Kintore to Tealing 400kV Overhead Line

Summary Report on Consultation - Alignment Selection

January 2025

Figure 9 - Proposed Alignment: Section A

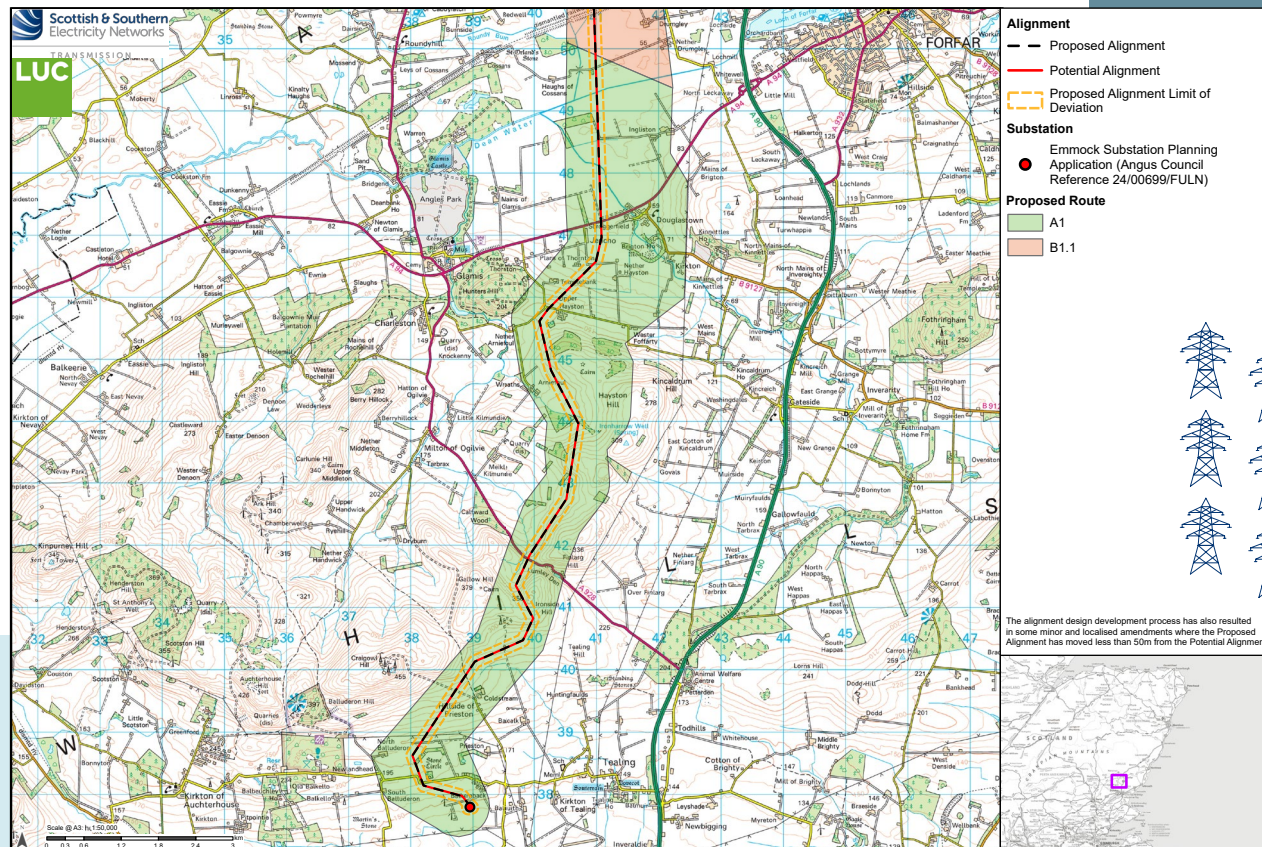
- Location: The overhead line was considered to have significant effects on the areas where people live. Suggestions were made that the overhead line should be moved further away from communities and homes.

- Landscape and visual: Concerns included the landscape and visual impact of the overhead line and towers on the area.
- Ecology: NatureScot noted potential impacts to specific designated areas e.g. the Firth of Tay and Eden Estuary Special Protection Area (SPA). Concerns raised by others related to impacts on migrating birds, bats and other wildlife, as well as habitats.

- Cultural heritage: Historic Environment Scotland (HES) and Aberdeenshire Council Archaeology Services (ACAS) noted a number of cultural heritage assets that may be impacted. Concerns raised by other respondents included impacts to local heritage such as ancient monuments near Tealing.

- Agriculture: Concerns were raised over the potential to damage farmland and impacts to farm animals given the amount of livestock in the area.
- Access: Concerns were raised about impacts of the project on roads including historic roads and roadside stone dykes and walls.

- Technical issues: Internet and phone services are considered to be poor in the area, and concerns were raised over the impact on internet and telecommunication services.

- Stakeholder communication: Concerns raised over the communication between SSEN Transmission and the community in relation to current survey activities being undertaken.

- Location: We have aimed to route the overhead line a target distance of 170m or more from residential properties and to maintain a minimum distance of 100m where possible taking account of other land uses.

- Landscape and visual: A landscape and visual impact assessment will be undertaken and reported in the Environmental Impact Assessment Report (EIAR), which will set out the measures to avoid, reduce and minimise landscape or visual impacts where possible.

- Ecology: Wherever possible, the alignment has avoided designated sites (such as SPA) and ensured that buffers and clearance areas are left between the project and designated sites to reduce impacts. The overhead line design has been developed to avoid and reduce impacts on habitats and species as far as possible. A full ecological assessment will be undertaken and reported in the EIAR setting out relevant mitigation proposals.

- Cultural heritage: Impacts to cultural heritage designations and interests will be assessed and reported in the EIAR, including any mitigation measures required.

- Agriculture: The alignment has been developed wherever possible to minimise effects on farms and farmland. We will continue to discuss access and construction arrangements with landowners to reduce disturbance.

- Access: Access to the project will avoid routes that could affect sensitive areas. Access is being developed working closely with landowners to minimise disruption.

- Technical issues: We are working closely with telecommunications operators to ensure that there will be no significant impacts from the project on telephone, internet and other communications infrastructure.

- Stakeholder communication: We will continue to work with affected landowners and communities to ensure that disruption from advance works is minimised. Any issues can be reported to the SSEN Transmission Community Liaison Manager.

Having reviewed the consultation feedback for Section A, no significant changes to the Potential Alignment are proposed.

In Section A we will take the Potential Alignment forward for the Environmental Impact Assessment and detailed design as our Proposed Alignment, as shown in **Figure 9: Proposed Alignment - Section A.**

Figure 10 - Proposed Alignment for Location 1: Hayston Hill

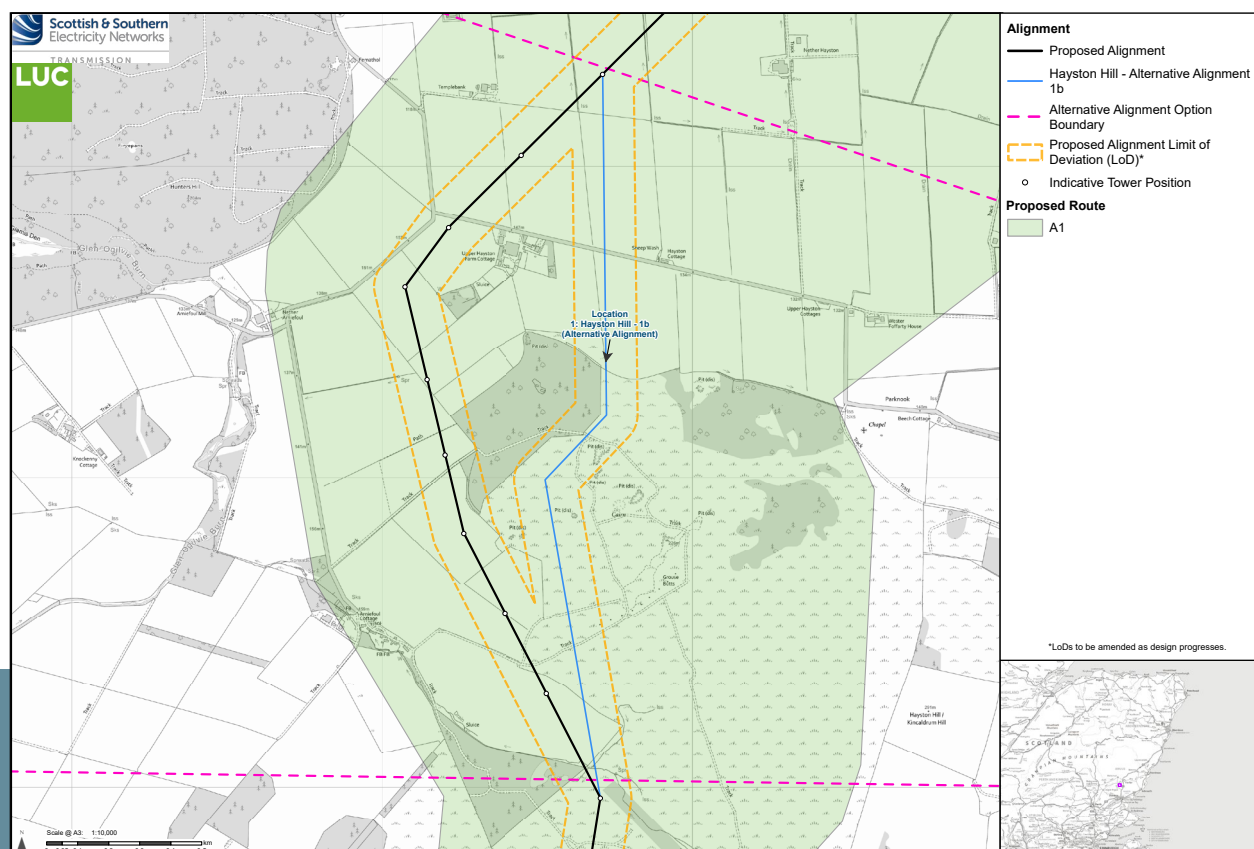
- Preference for Potential Alignment 1a as Alternative Alignment 1b was much closer to the scheduled monument at Arniefoul Cairn, as raised by HES and ACAS.

- Angus Council noted Potential Alignment 1a may be closer to residential properties.
- Alternative Alignment 1b would better protect the unique character of the environment and would have less impact on ecosystems, people and local tourism businesses.
- Alternative Alignment 1b would be shorter, would have fewer impacts overall, would require less material and time to build and cause less access and road damage and disruption.
- Alternative Alignment 1b would have a lesser impact on agricultural land.
- It was felt the Nether Arniefoul Unenclosed Settlement was considerably closer to Potential Alignment 1a than Alternative Alignment 1b.
- Alternative Alignment 1b would have less impact on watercourses and flood risk, and less impact on forestry.

- Proximity to property and the potential for adverse visual effects at locations such as Arniefoul and Hayston is considered to be similar for both alternatives and the alignment will be developed to target a separation distance of 170m or more from residential properties and to maintain a minimum distance of 100m where possible, taking account of other land uses.

- The Potential Alignment 1a provides greater opportunity to reduce landscape impacts by crossing areas that are less hilly.
- Cultural heritage constraint is considered to be greater for Alternative Alignment 1b and any potential impacts on archaeology will be assessed and mitigated wherever possible in the EIAR.

- Alternative Alignment 1b would cross more extensive areas of upland hill land with more sensitive heath habitats. The alignment design will be developed to minimise woodland loss where possible and mitigation for any potential effects on water supplies will be set out in the EIAR.

- Alternative Alignment 1b is slightly shorter than the Potential Alignment 1a and is considered to have similar technical challenges, although it crosses more challenging ground conditions at higher altitude.

Having reviewed the consultation feedback for this alignment location, including statutory consultee responses, it is considered that Potential Alignment 1a remains less constrained overall in relation to the environmental and technical criteria appraised.

In this location we will take **Potential Alignment 1a** forward for the Environmental Impact Assessment and detailed design as our Proposed Alignment, as shown in **Figure 10: Proposed Alignment for Location 1: Hayston Hill**.

Figure 11 - Proposed Alignment: Section B

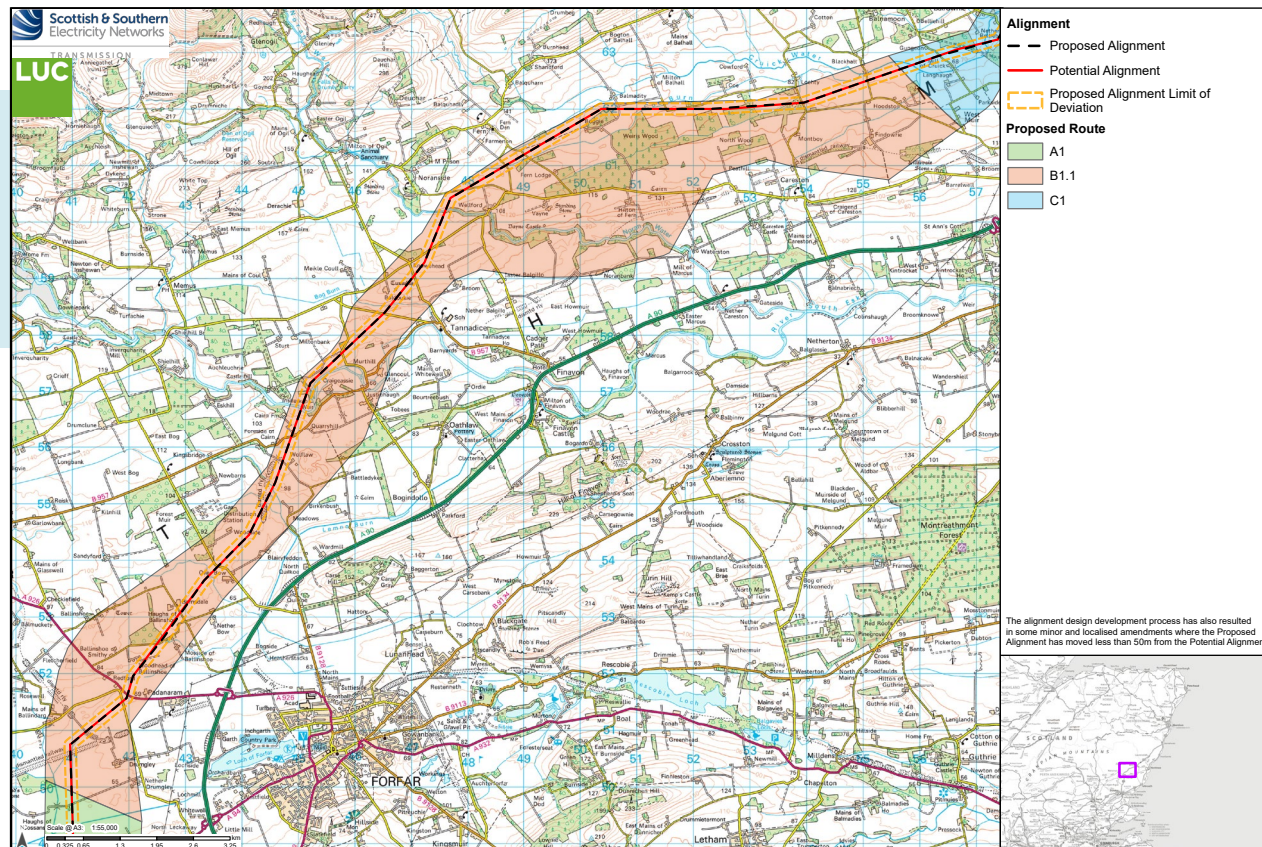
- Location: Some felt that some properties were missing from the mapping used in the Consultation Document (e.g. around Padanaram). The overhead line was considered to have significant effects on the areas where people live especially where there are already overhead lines in the area, with the suggestion that the new overhead line will create a 'wrap around' effect along with other overhead lines. Suggestions were made that the overhead line should be moved further away from communities.

- Ecology: Feedback highlighted concern about impacts on specific sites, e.g. Lochty Wood, Ancient Woodland, wetlands and protected species. The Esk District Salmon Fishery Board (DSFB) noted River South Esk salmon spawning grounds and fishing areas. The possibility of potential impacts on designated sites e.g. the Montrose Basin Site of Special Scientific Interest (SSSI), SPA and Ramsar site was raised by NatureScot.

- Cultural heritage: Feedback from HES and ACAS highlighted potential for setting impacts on specific sites, e.g. the Brown and White Caterthun hill forts, Battledykes Roman Camp. Local residents noted some local historical aspects, e.g. Lochty fields crop marks.

- Water resources: Concerns were raised by the Esk DSFB with regards to the potential risk of riverbank erosion and an increase of fine sediments in the River South Esk. Concerns were raised relating to the possible increase in the risk of flooding, noting a long history of flooding in the area.

- Access: Concerns were raised about the poor existing road conditions and single track roads. It was noted that many bridges are historic with traffic and weight restrictions. Road conditions and traffic management are felt to be currently under pressure across the area.

- Health: Concerns raised over the impact on health due to the proposed proximity of the overhead line to residents and schools.
- Agriculture: Concerns over the impact to farming practices (e.g. size of plant operating around overhead line and towers) access to fields, impacts on prime agricultural land, biosecurity issues and impacts on field drains.

- Technical issues: Concerns were raised over the possible impact to internet and telecommunication services from electromagnetic interference. The area is also used for low flying military aircraft. Potential impacts on the existing sewerage system were also identified.

- Stakeholder communication: It was noted by some tenants/tenant farmers that they have not been directly contacted in the same way that landowners have despite being directly impacted.

- Location: With regard to properties not shown on our base mapping, the Ordnance Survey (OS) base maps we have used are the latest available, dated July 2024. We do not however rely on OS base maps to identify properties, and we use the latest versions of AddressBase data, which we overlay on our mapping systems. We also collect up to date aerial imagery to ensure we are including all properties. Our land teams are also on the ground liaising directly with landowners. A landscape and visual impact assessment will be undertaken and reported in the EIAR, it will consider existing overhead lines and set out relevant measures to avoid, reduce and minimise landscape or visual impacts.

- Ecology: Wherever possible, the alignment has avoided designated sites (such as SPA) and ensured that buffers and clearance areas are left between the project and designated sites to reduce impacts. The overhead line design has been developed to avoid and reduce impacts on habitats and species as far as possible. A full ecological assessment will be undertaken and reported in the EIAR setting out relevant mitigation proposals.

- Cultural heritage: Impacts to cultural heritage designations and interests will be assessed and reported in the EIAR, including any mitigation measures required.

- Water resources: We are liaising with the Scottish Environment Protection Agency (SEPA) and will undertake a full water resources and flood risk assessment which will be reported in the EIAR along with mitigation measures. Watercourses will be protected during construction.

Having reviewed the consultation feedback for Section B, no significant changes to the Potential Alignment are proposed.

In Section B we will take the Potential Alignment forward for the Environmental Impact Assessment and detailed design as our Proposed Alignment, as shown in **Figure 11: Proposed Alignment - Section B.**

- Access: We will undertake surveys of all roads and access points prior to construction and undertake a Traffic and Transport Assessment. Traffic will be carefully managed and road conditions will be monitored, photographed and repaired if damaged.

- Health: We have aimed to route the overhead line a target distance of 170m or more from residential properties and to maintain a minimum distance of 100m where possible taking account of other land uses.

- Agriculture: The alignment has been developed wherever possible to minimise effects on farms and farmland. We will continue to discuss access and construction arrangements to reduce disturbance.

- Technical issues: We are working closely with telecommunications operators to ensure that there will be no significant impacts from the project on telephone, internet and other communications infrastructure. We are also liaising with the Ministry of Defence and Scottish Water.

- Stakeholder communication. Our land teams are liaising directly with landowners and are aware of affected properties. We will continue to work with affected landowners, land managers, tenants and communities as the project progresses.

Figure 12 - Proposed Alignment for Location 2: Padanaram

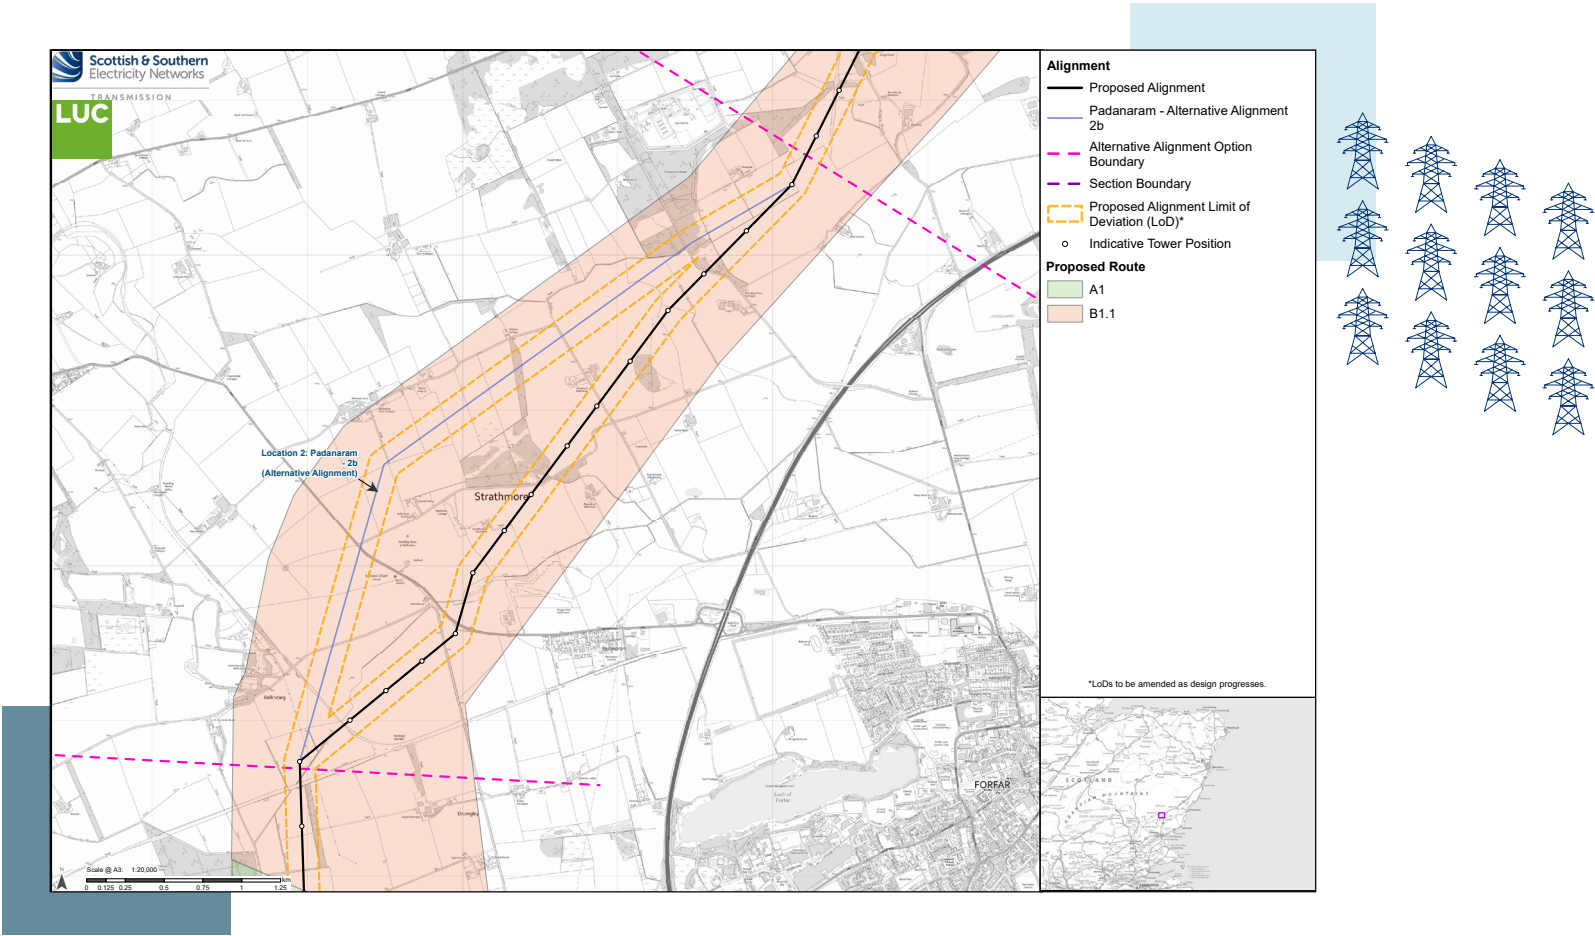
- Some felt that Potential Alignment 2a has an overhead line near it already and infrastructure should be kept together to minimise impacts elsewhere.
- It was felt that Alternative Alignment 2a would have less impact on telecommunications.
- Potential Alignment 2a would significantly reduce the impact on high quality agricultural farmland and farming operations.
- Concerns were raised by ACAS about the potential impact on the setting of cultural heritage features including Ballinshoe Castle, citing a preference for Potential Alignment 2a.

- Angus Council noted that Potential Alignment 2a could result in greater impacts on residential receptors north of Padanaram around Ballinshoe and to some residential and farm settings than Alternative Alignment 2b.

- Some residents of Padanaram were concerned that the existing overhead line near the village has not been considered in the assessments and residents would be over-exposed to the environmental, socio-economic and health effects from overhead lines, with noise noted as a particular issue from the existing overhead line.

- The route of the overhead line near Padanaram of Potential Alignment 2a would have a direct impact on migratory geese and swans.
- Alternative Alignment 2b significantly reduces the impact to farmland compared to Potential Alignment 2a.

- Potential Alignment 2a includes works to protect a gas main and would have more construction impacts than Alternative Alignment 2b.
- Some respondents, including Forfar Community Council, had a preference for Alternative Alignment 2b based on the fewer number of dwellings impacted and that it would be less impacted by flooding.

- Both alignments were developed to avoid the main settlement area at Padanaram.
- Proximity to property and potential for adverse visual amenity and related effects such as operational noise from the overhead line is considered to be similar for both alternatives. The overhead line will be developed to maintain a target separation distance of 170m or more from residential properties and to maintain a minimum distance of 100m where possible, taking account of other land uses. Constraint from farmland and areas at risk of flooding is not materially different between the two alternatives.
- Similarly, the level of constraint from migratory birds such as geese and swans was appraised as being comparable.
- Alternative Alignment 2b has been evaluated as being more technically constrained than the Potential Alignment 2a in relation to proximity to an adjacent high pressure gas pipeline.

Having reviewed the consultation feedback for this alignment location, including statutory consultee responses, it is considered that the Potential Alignment 2a remains less constrained overall in relation to the environmental and technical criteria appraised.

In this location we will take **Potential Alignment 2a** forward for the Environmental Impact Assessment and detailed design as shown in **Figure 12: Proposed Alignment for Location 2: Padanaram**.
